MEMORANDUM

SUBJECT: Consideration of Conifer Ridge Apartments, County Road D East, between Hazelwood Street North and Kennard Street

- A. Comprehensive Plan Amendment
- B. Planned Unit Development Revision
- C. Public Easement Vacations
- D. Lot Division
- E. Design Review

TREE AND BUSH PLANTING AND SCHEDULE

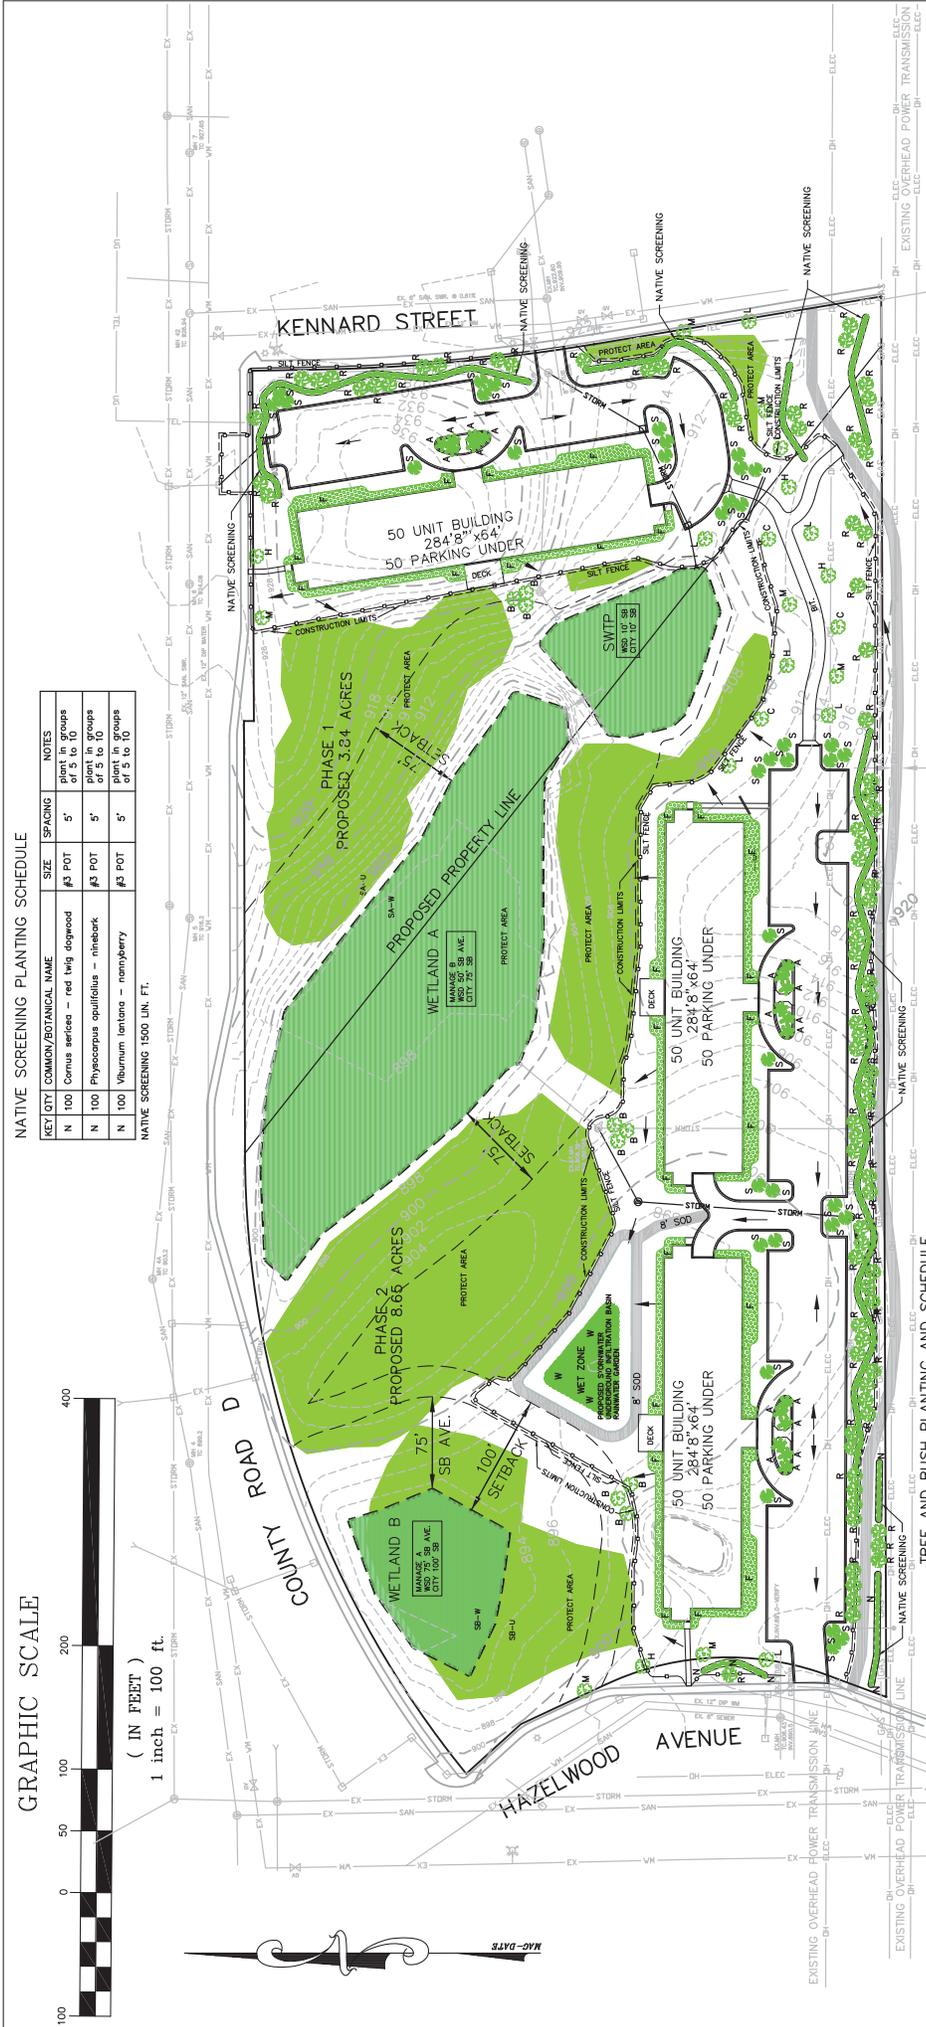
In order to be consistent with the original 2003 Legacy Village approvals, overstory trees must be planted along the west side of Kennard Street and the east side of Hazelwood Street at an average of 30'-40' on center. In addition, screening, either with a fence or landscaping, must be provided between the parking lots and the adjacent property lines. The ordinance requires screening to be at least 6 feet tall and 80 percent opaque and landscape screening can be done with a mixture of berming and vegetation.

The landscape plan calls for 148 replacement trees, 900 native screening and foundation plants, and several other non-native shrubs that don't count toward the tree replacement requirement. Overall, the applicant is replacing 895 caliper inches of trees on the site, with 694.30 caliper inches of replacement trees remaining. To mitigate the trees further, the applicant has agreed to remove all of the buckthorn from the site and pay for the management of that buckthorn over a three-year period.

- Provide a revised landscaping plan for staff approval which include the required overstory trees along Hazelwood Street and Kennard Street and detailing how screening requirements are being met for the parking lots facing residential areas.

WEST ELEVATION
 302' = 1'-0"

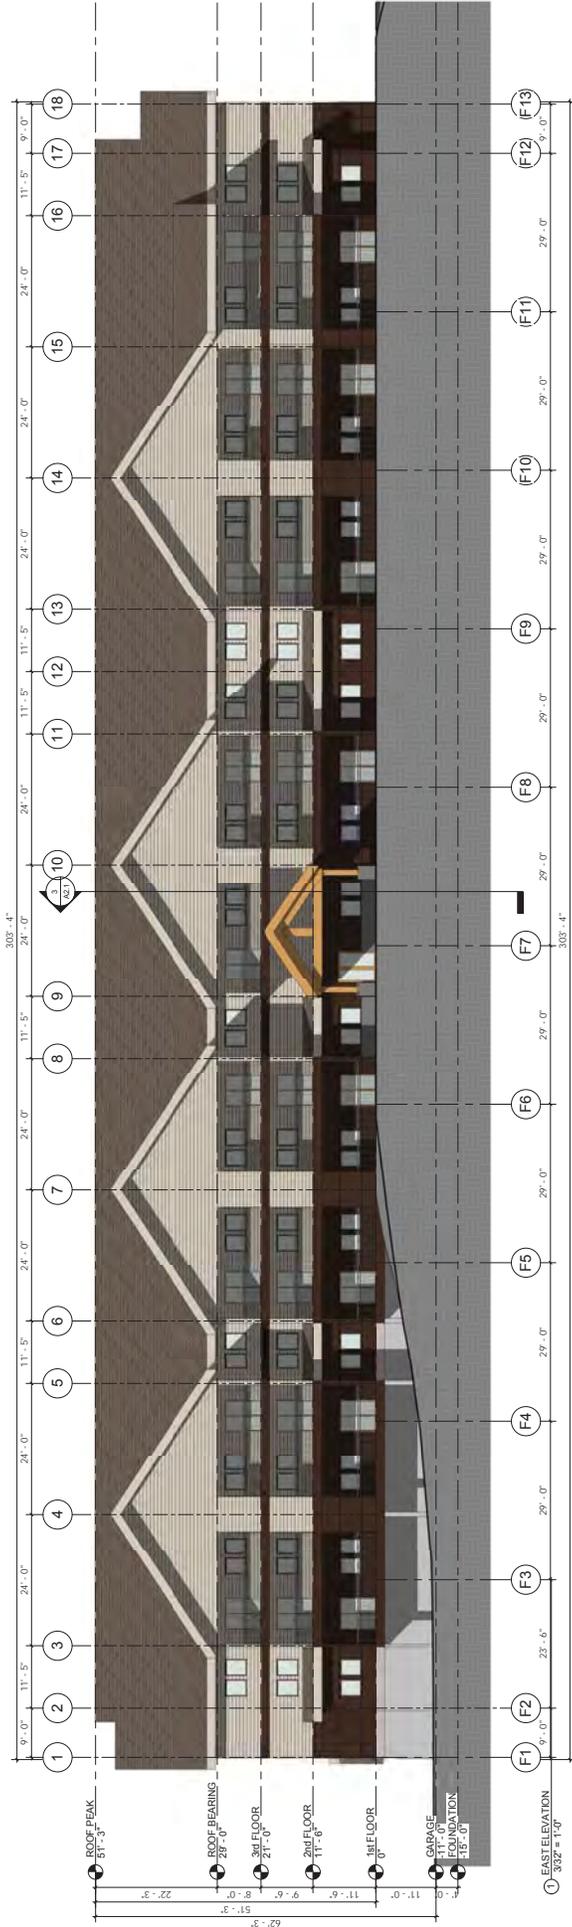
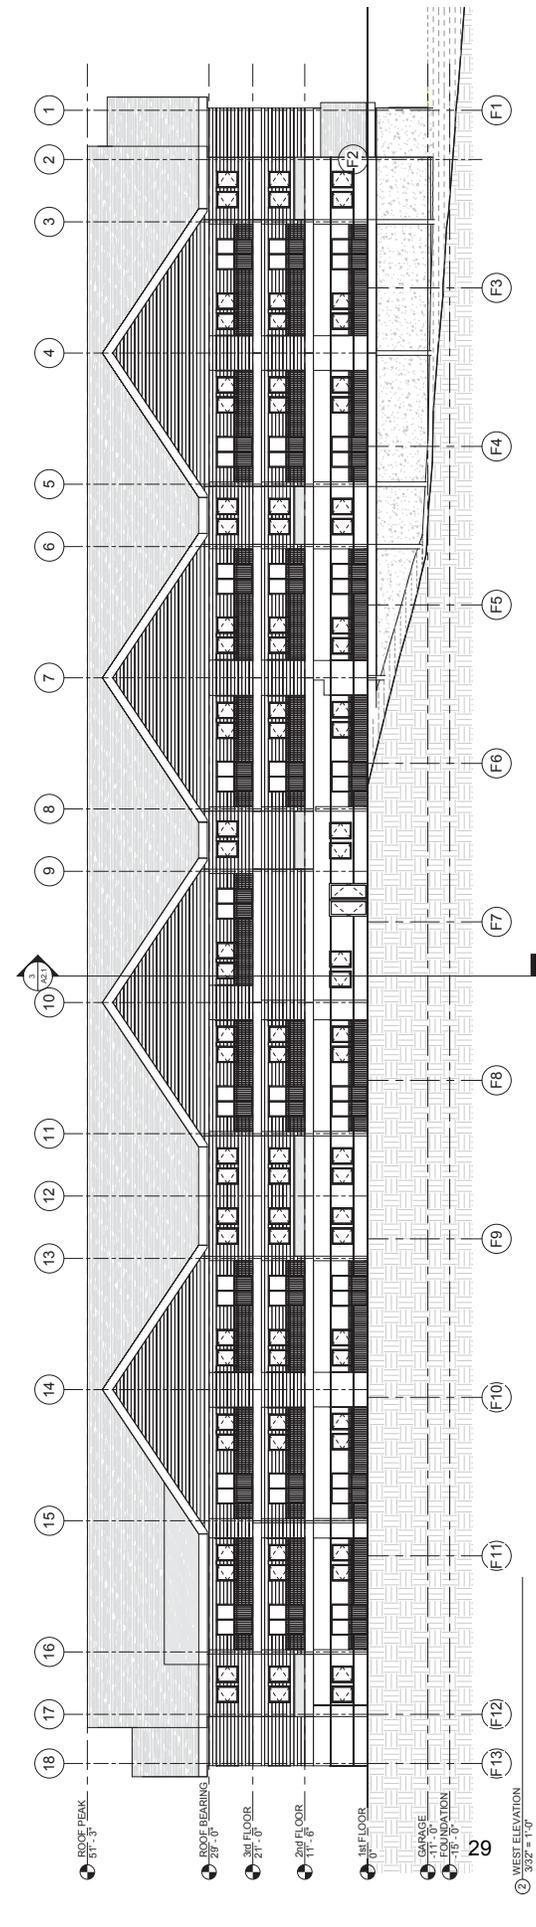
The proposed apartment buildings would be attractively designed but staff would like to see more effort put into matching some of the design elements found elsewhere in Legacy Village. The applicant's plans propose the use of cement board lap siding for the upper two floors and board and batten cement board for the lower floor. Staff would recommend the applicant add brick or stone into the elevations to match design elements found in the nearby townhomes. In addition, some type of architectural feature should be added to the gable areas on the buildings' third level.

- Provide revised building elevations for staff approval incorporating brick elements into the buildings and adding architectural features to the gable areas of the buildings.
